THE GRAND BAHAMA PORT AUTHORITY, LIMITED

Building Inspection Report on Silver Point Apartment Building

SUBJECT: **Silver Point Condominiums – Bahama Reef Section 2, Tract C (A Portion of) Group Inspection**

Photo#13 illustrating moderate, concrete crack defects at the CMU balcony rail.

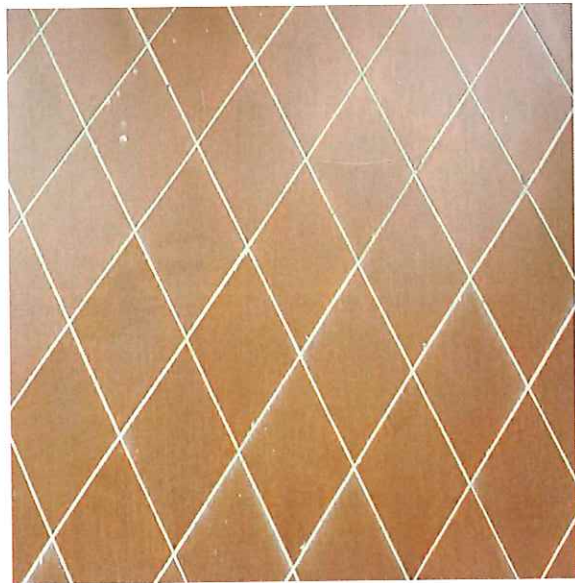
1. At the eighth (8th) floor, moderate concrete crack defects were identified within the eastern stairwell at the CMU walls. More moderate concrete crack defects were identified along the exterior CMU walls and reinforced concrete columns close to room #82, as well as along the exterior northern facing concrete balcony rail.

All concrete defects should be repaired based on the recommendations from a GBPA's licensed structural engineer of record. Rebars that are severely corroded should be replaced where necessary based on the engineer's report. If the defects are left un-attended for much longer they will only get worst and possibly lead to injuries to the occupants of the building.
